Appeal Resolution for Congaree River in Richland and Lexington Counties, South Carolina

September 26, 2000

Executive Summary

Figure 1. Weighted Frequency Curve

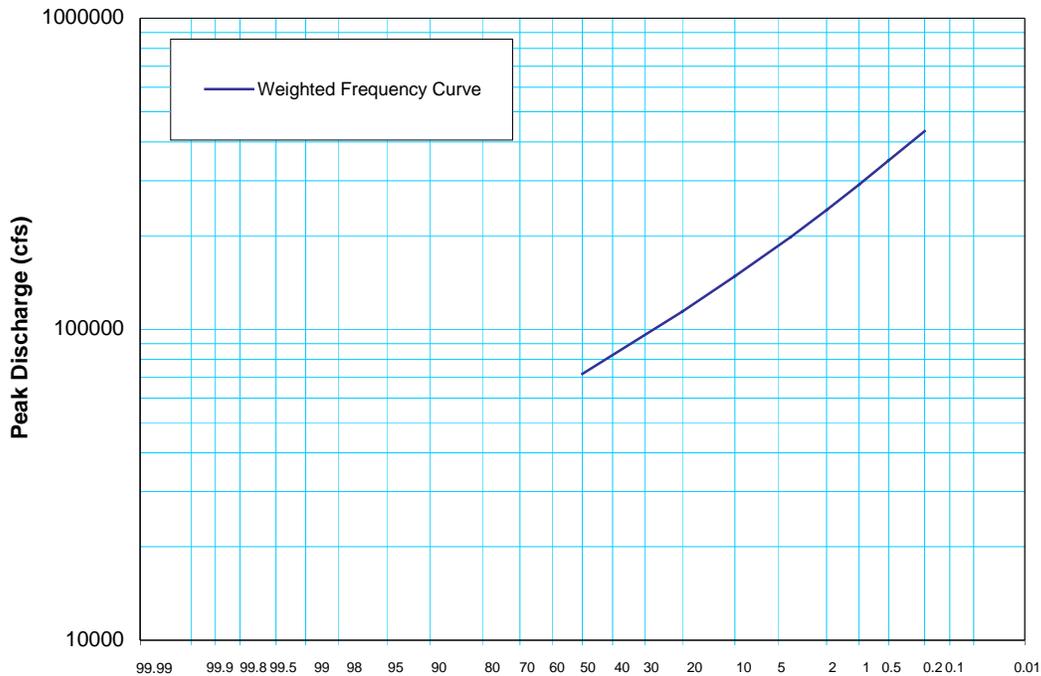
Figure 1 shows the weighted frequency curve by weighting flood discharges from Methods 2 and 3B.

The 1-percent annual chance flood discharge for the weighted frequency curve in Figure 1 and in Table 1 is 292,000 cfs. The standard error of this discharge was not estimated because we do not know the equivalent years of record of the weighted flood frequency curve. However, it is likely that the standard error of the weighted 1-percent annual chance discharge is in the range 18-22 percent, the standard errors for Methods 3B and 2, respectively.

The weighted frequency computations were transmitted to the USGS, which concurred with FEMA's approach for weighting two different methods for determining the base flood discharge. In a letter dated August 17, 2000, USGS agreed that 292,000 cfs is a valid estimate of the base flood discharge for the Congaree River at Columbia.

Figure 2. Dike Sections Conducive to Piping Failure

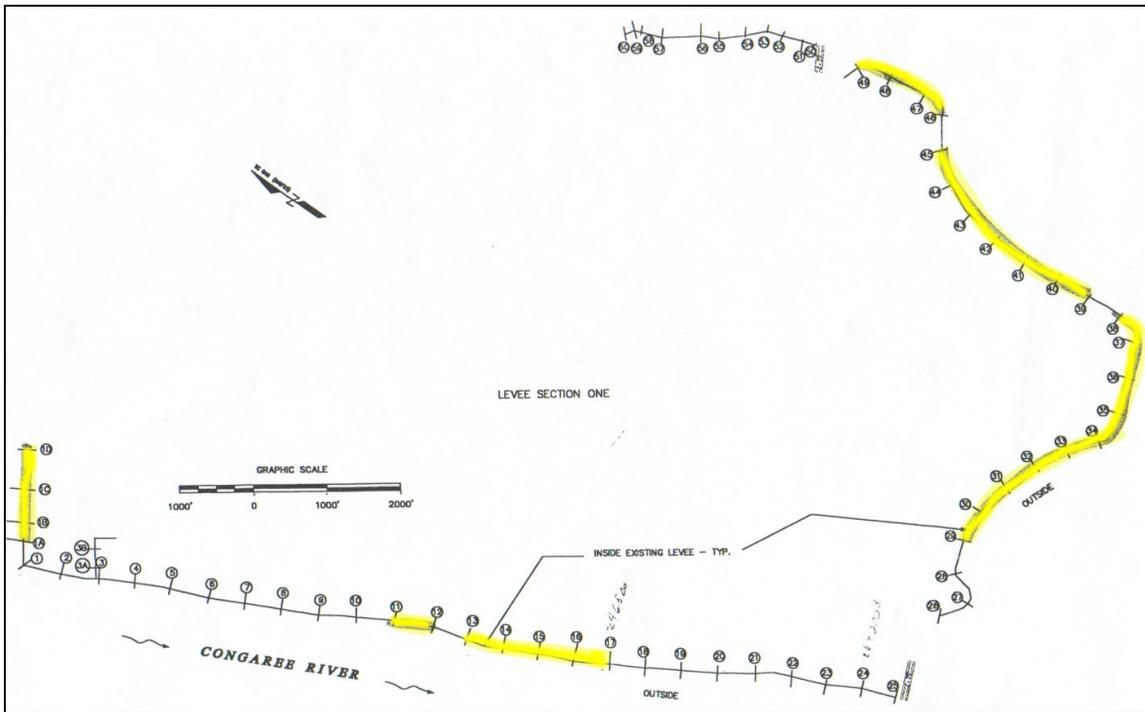
The first question was answered by investigating the potential for failure by piping. Piping is the most likely mode of failure, as demonstrated by the two areas that failed in 1976. Shear failure itself is not a likely cause of breaching because of the relatively low height of the levees to the ground, and the fact that they have gained some degree of stability through consolidation over many years. It is possible that there could be some sloughing and sliding of the steeper landside slopes, but this would probably be due to the effect of seepage causing piping and removal of some landside toe support, as is suspected in the south failure during the 1976 flood. Dike sections that had conditions conducive to piping failure were identified; these are shown in Figure 2.

Figure 5. Roughness Coefficients – Material Properties

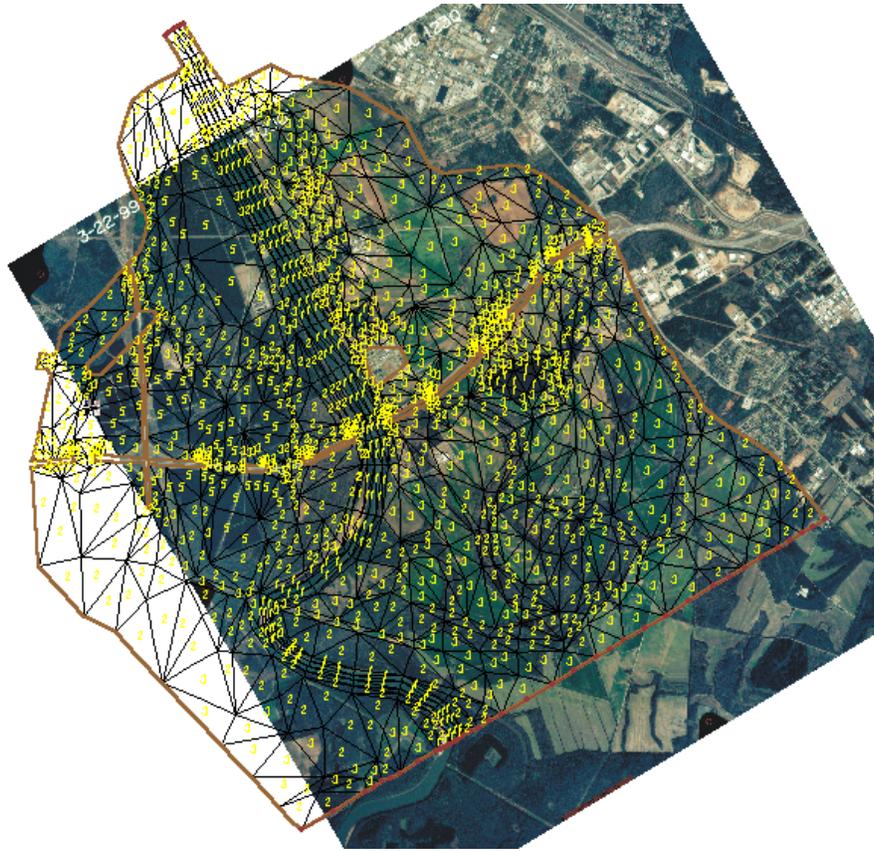
This initial estimate was modified during the calibration of the RMA-2 model to high-water marks obtained during the 1976 flood event. The roughness coefficients were reviewed and updated using a current aerial photograph (flown on March 22, 1999) of the lower Congaree River floodplain. Major changes to the roughness coefficients occurred in the areas of the planted pine forest in Lexington County. The Manning’s roughness coefficients were revised to reflect the mature pine trees existing in this area.

The final set of roughness coefficients used in the RMA-2 model are provided in Table 3. Figure 5 illustrates the distribution of the different roughness coefficients within the finite element mesh superimposed on an aerial photo of the lower floodplain.

Figure 7. Water Surface Elevation; Manning's Levee with Two Piping Breaches

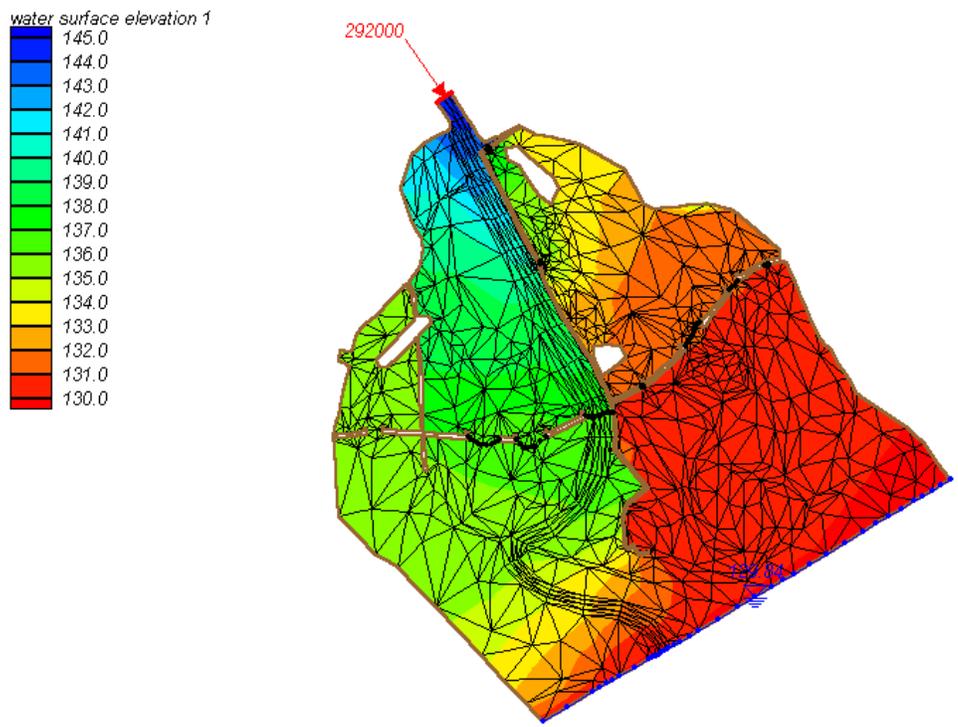
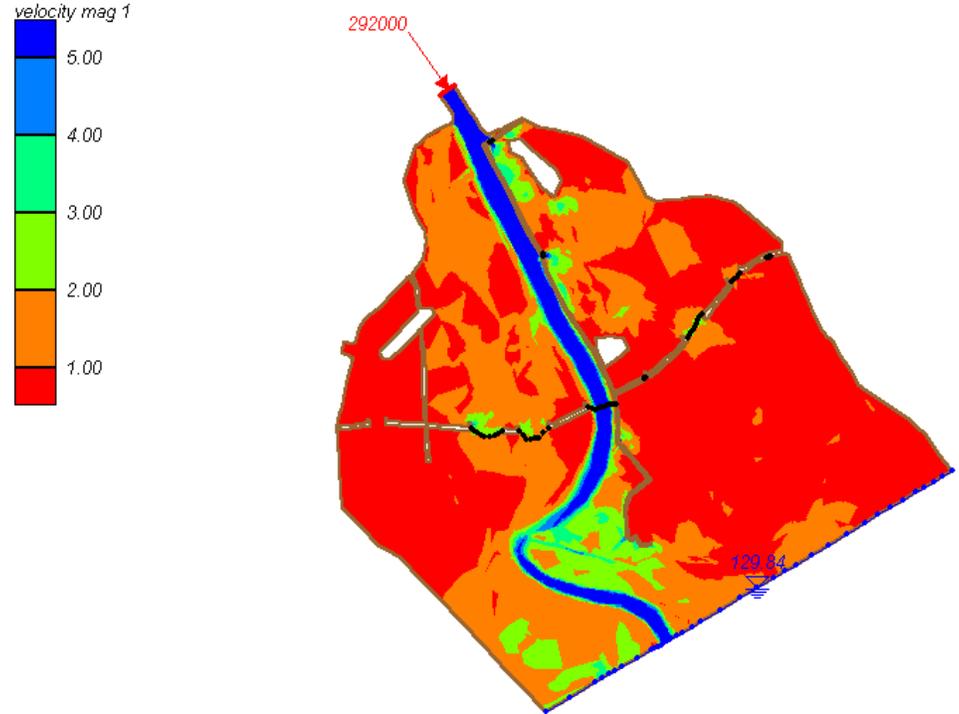
The geotechnical evaluation previously discussed above identified two locations as having the highest likelihood of breach by piping. One location is on the northernmost end of the levee where it runs in an east-west direction just before the levee turns south. The other location is approximately 3,000 feet upstream of the I-77 crossing. Both breaches would have a width of approximately 120 feet. The grid was adjusted by inserting elements in the location of the breaches along the levee and refining the grid around these locations. An area of high ground on the Richland County side that would be dry with the levee in place was taken out of the model in order to get better convergence of the model in the area of the breach. The model was run assuming both breaches would occur simultaneously. The results can be seen in Figures 7 and 8.

The results show that approximately 9.6 percent of the total Congaree River discharge will enter the Richland County side of the floodplain through the two breaches.

Figure 11. Percent Flow Passing versus Single Breach Width

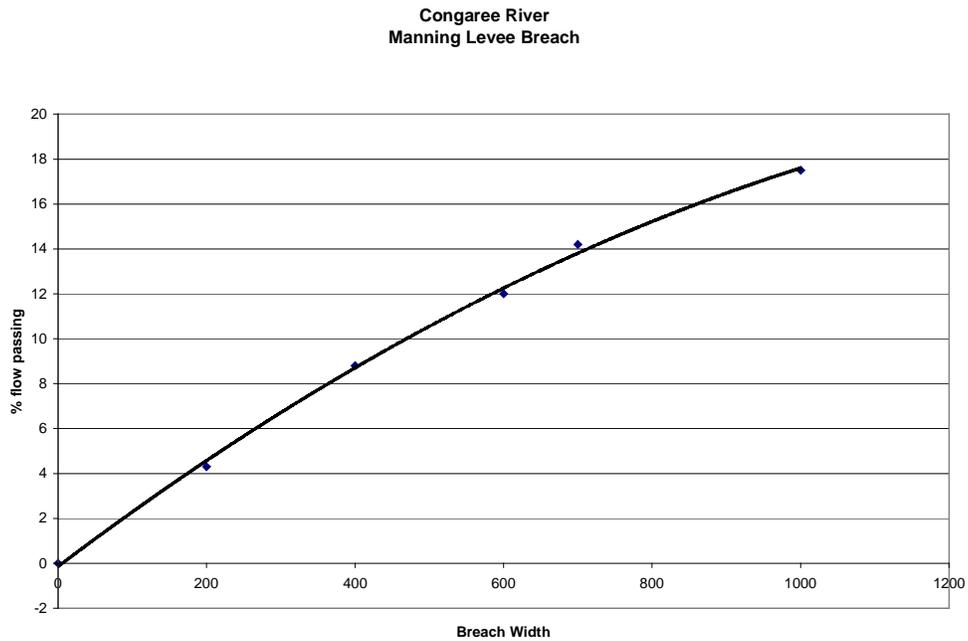
A range of breach widths was simulated with RMA-2 to determine the percentage of flow that would enter the Richland County floodplain with each different breach width. The results are shown on Figure 11.

Using the HEC-2 model with the Manning's dike in place, it was determined that allowing 5.5 percent of the total flow to enter the Richland County floodplain would decrease water-surface elevations in the Lexington County floodplain by approximately 1 foot. Using Figure 11, the 5.5 percent flow in Richland County floodplain would correspond to a breach width of approximately 250 feet. This means that if Manning's dike were considered to restrict flow in Lexington County, a breach greater than 250 feet wide would lower water-surface elevations by more than 1 foot in Lexington County.

Based on these investigations with the RMA-2 model, it was concluded that the Richland County floodplain would convey a significant amount of flow in a 100-year flood. Specifically, it was determined that the large (1,320 feet wide) relief bridge is critical to conveying the Congaree River flow during a 100-year flood. Therefore, based on the two-dimensional model investigation, it was determined that the floodway should extend landward of Manning's dike in Richland County, and should allow for flow through the large relief bridge.
